SUBJECT: INITIAL EXAMINATION REPORT NO. 50-188/OL-10-02,  
KANSAS STATE UNIVERSITY

Facility Comments With NRC Resolution.

U. S. NUCLEAR REGULATORY COMMISSION  
NON-POWER INITIAL REACTOR LICENSE EXAMINATION

FACILITY: Kansas State University

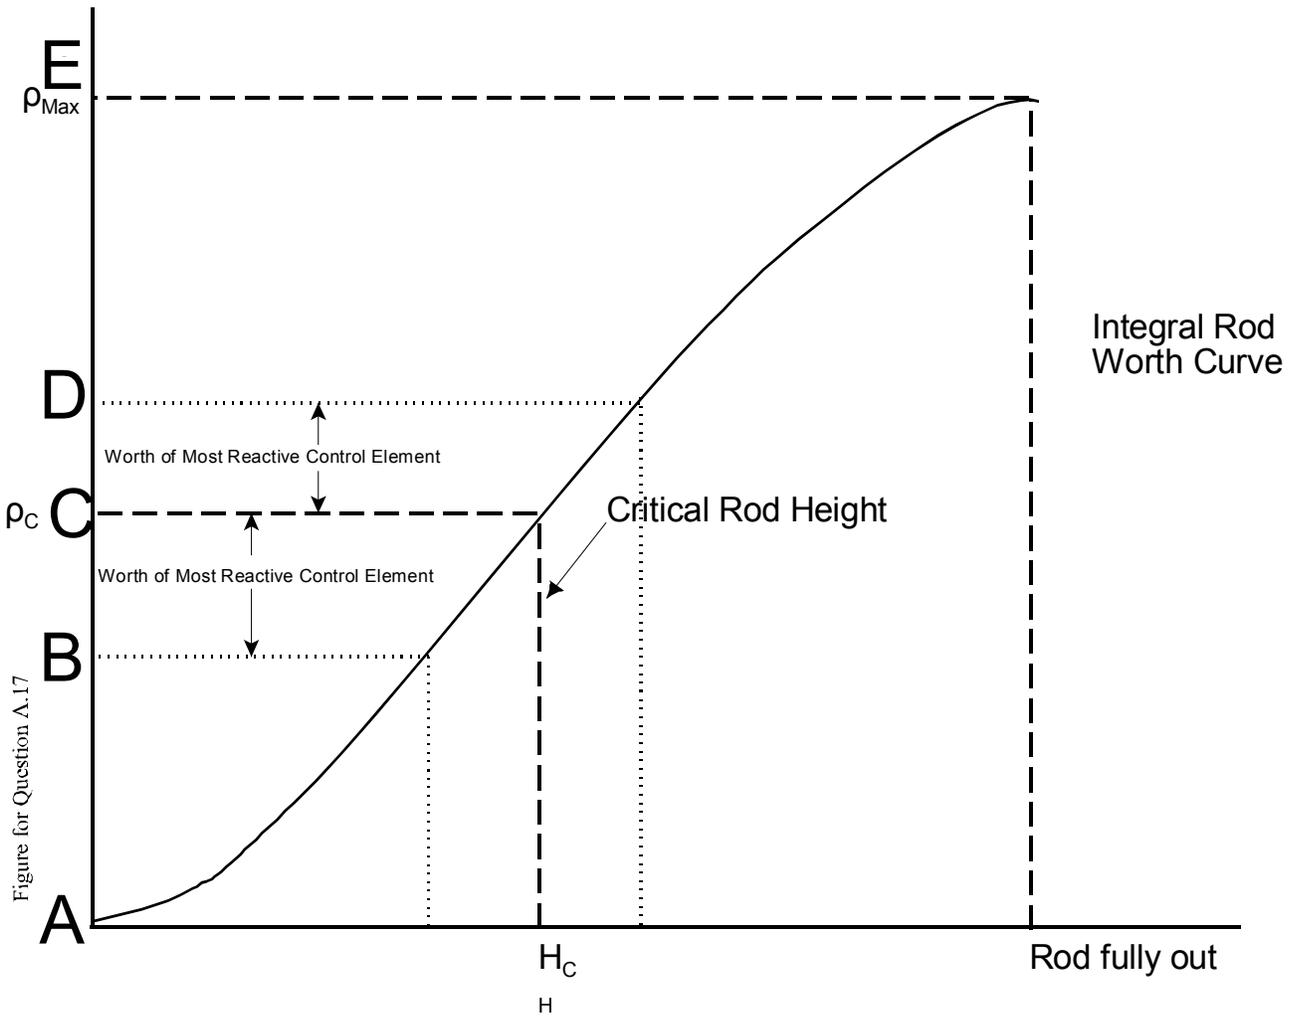
Question A.020c

Comment: The correct technical specification shutdown margin (c) appears to be 1: B-A, not 6: E-D. The Facility recommends that the answer be changed accordingly.

NRC Resolution: Comment accepted. Correct answer for A.020c changed from (6) to (1).
